Access Compliance Report

Public Rights-of-Way

Intersection ID: N/A	Main Street: RIDGE_OAK_DR	Cross Street: CAROLINA_CROSSING_DR	Location: SW
ADA ID: 75D83D62FCAC	Ramp Type: BlendTrans2	Initial Pass/Fail: Fail	Overall Compliance: No
		Severity Score: 10

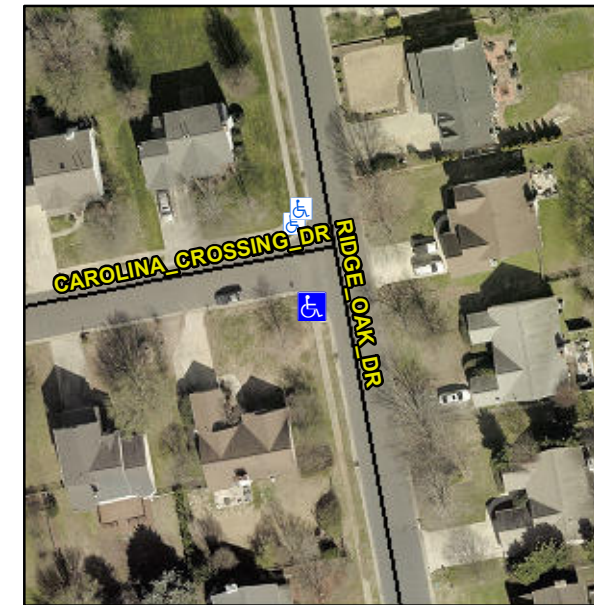
Not Found, R304.5.1, R304.5.3

Compliance	Description	Data	Compliance	Description	Data
N/A	Ramp Length (in)	91.0	Yes	BlendTrans Slope (%)	4.4
No	Ramp Width (in)	36.0	No	BlendTrans XSlope (%)	4.0
N/A	Flare Type LT	N/A	N/A	Flare Type RT	N/A
N/A	Flare Slope LT (%)	N/A	N/A	Flare Slope RT (%)	N/A
N/A	Flare Traversable LT?	N/A	N/A	Flare Traversable RT?	N/A
N/A	Landing Length (in)	N/A	N/A	DWS Provided?	N/A
N/A	Landing Width (in)	N/A	N/A	DWS Contrast?	N/A
N/A	Landing Slope (%)	N/A	N/A	DWS Length (in)	N/A
N/A	Landing X Slope (%)	N/A	N/A	DWS Full Width?	N/A
N/A	Landing Curb? (Y/N)	N/A	N/A	DWS Offset (in)	N/A
N/A	Shared Landing?	N/A			
N/A	Gutter Ponding?	N/A	N/A	Gutter Slope (%)	N/A
N/A	Gutter Lip Ht (in)	N/A	N/A	Gutter X Slope (%)	N/A
N/A	Painted X Walk1?	No	N/A	Painted X Walk2?	No
	X Walk 1 Direction	To E		X Walk 2 Direction	To N
	X Walk 1 Width (in)	N/A		X Walk 2 Width (in)	N/A
	X Walk 1 Slope (%)	1.9		X Walk 2 Slope (%)	1.3
	X Walk 1 X Slope (%)	2.1		X Walk 2 X Slope (%)	0.6

N/A	Ramp inside XWalk1?	N/A	N/A	Ramp inside XWalk2?	N/A
	Road Slope (%)	2.1		Clear Space?	N/A
	Road X Slope (%)	3.6	N/A	Clear Space to XWalk (in)	N/A
N/A	Any Obstructions?	N/A	N/A	Storm Grate/Utility Hazard?	N/A
	Obstruction Type			Storm Grate/Utility Type	
		N/A			N/A
			Yes	Surface Condition? (G/P)	Good
			No	Curb Slope (%)	12.1

Remove & Replace Curb Ramp With Two New Directional Ramps or Equivalent.
